Report to Development Permit Panel

To: Development Permit Panel
From: Joe Erceg
Manager, Development Applications
Date: August 7, 2002
File: DP 02-205966
Re: **Application by Westbank Projects Corporation for a Development Permit at
11760 Steveston Highway**

Mattu Lot,
Ironwood Plaza,
11760 Steveston Hwy.

Site
Plan

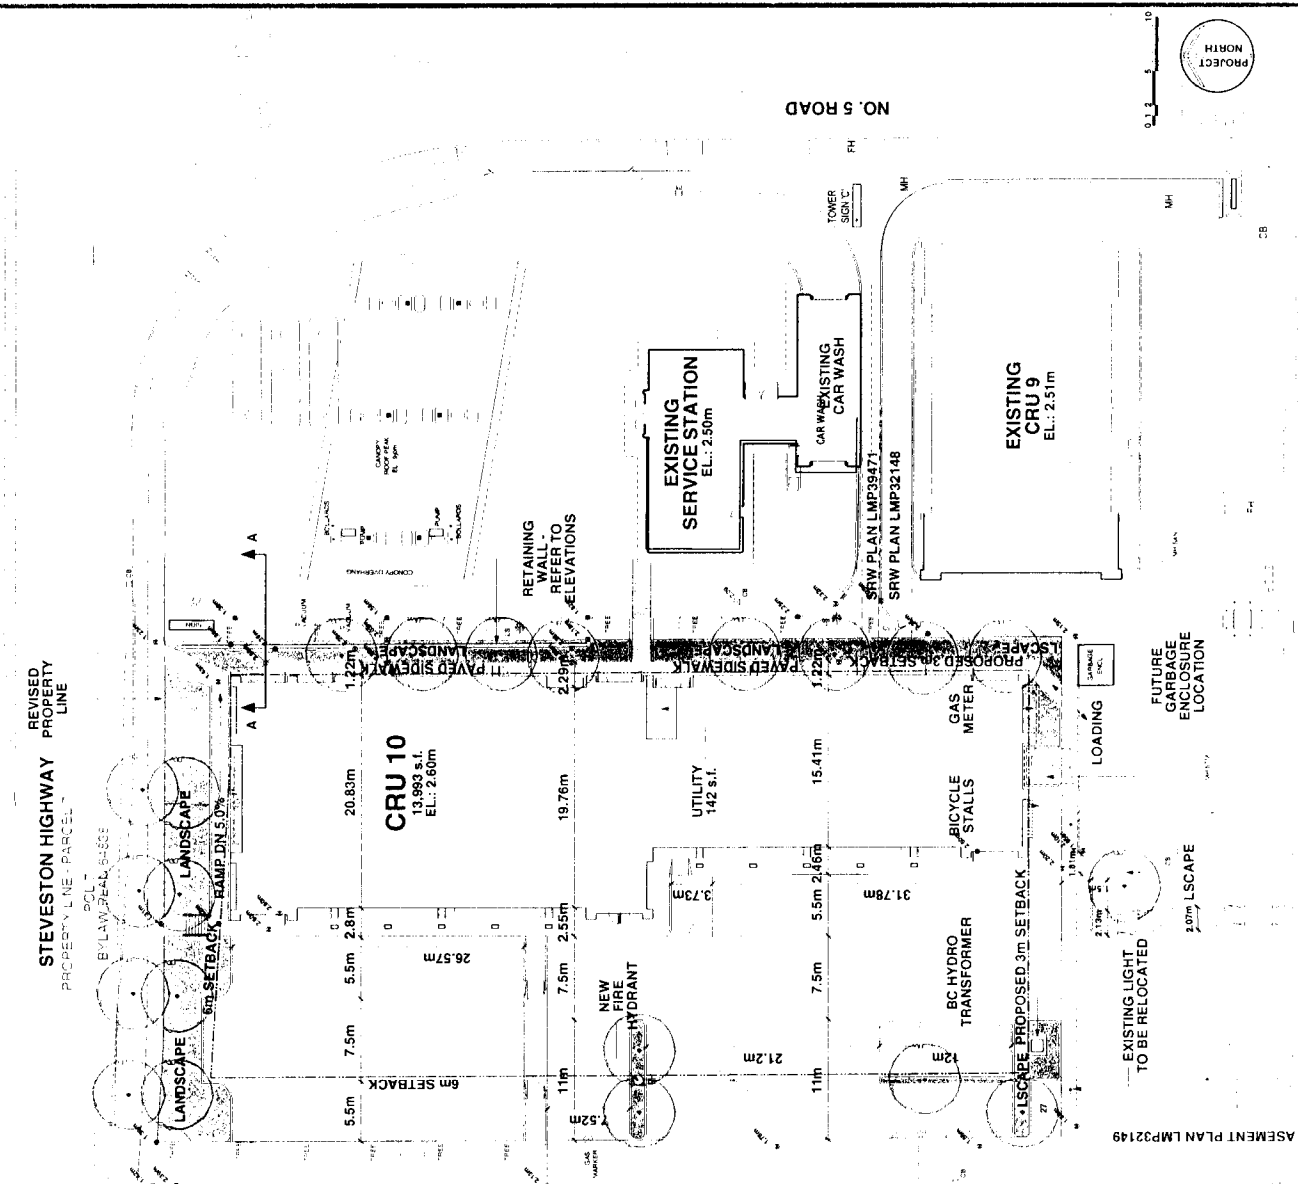
1. Please provide an explanation as to how loading would be accommodated on the subject site. ***A loading area has been delineated on the Ironwood site.***
2. The garbage enclosure at the southeast corner of the site should be relocated/reconfigured to permit improved access to the rear of the commercial/retail units. ***The garbage enclosure has been removed. A possible future location for the enclosure has been moved to the west to widen the space between the existing CRU 9 garbage enclosure and the building. The easement on the Lands for City service to the future garbage enclosure location is still to be included as part of rezoning application RZ-02-199709.***

3. A concrete sidewalk should be installed along the eastern side of the building instead of crushed gravel. ***A concrete sidewalk has been provided.***

4. A ramp for disabled persons should be provided from Steveston Highway into this site or on the eastern portion of Ironwood Plaza. ***A ramp has been provided.***

5. The “future patio” must be deleted since there are no food catering establishments proposed in this building according to the parking calculations. ***The future patio has been deleted.***

7. The extent of the building overhang(s) should be shown on the site plan. ***Overhang extents have been shown.***
8. Adequate turn around space needs to be provided for the two parking spaces located closest to Steveston Highway. ***A turnaround space has been provided, although not common as a standard detail to either Ironwood Plaza or Coppersmith Place.***

9. The pedestrian connection through the Ironwood Plaza should be more direct plus raised where appropriate. ***The pedestrian connection has been straightened.***

3. Improve on-site pedestrian circulation including a new accessible pedestrian connection between the boulevard along Steveston Highway and the site and consider a pedestrian link with the Chevron Station immediately to the east. ***A ramp to Steveston has been provided. A pedestrian connection to the Chevron building has been provided.***

4. Consider eliminating one parking stall to achieve an improved pedestrian link with the existing shopping plaza and library to the south that could incorporate outdoor seating. ***One parking stall has been eliminated from the Ironwood site to better facilitate the pedestrian connection back to Ironwood.***

5. Provide a row of trees along the east property line at a minimum caliper size of 10 cm (4 inches). ***We have provided a row of trees along the eastern edge as requested***

1. Straighten diagonal pedestrian crossing and allow for wheelchair accessibility. ***One parking stall has been eliminated from the Ironwood site, the pedestrian connection has been straightened and let-downs for wheelchair access have been provided.***
2. Raise the pedestrian link across the main east west internal road to the south of the subject site. ***The pedestrian link along the main east-west access has been raised.***
3. Provide a turnaround capability for the parking stalls at the northerly end of the site. ***A turnaround space has been provided.***
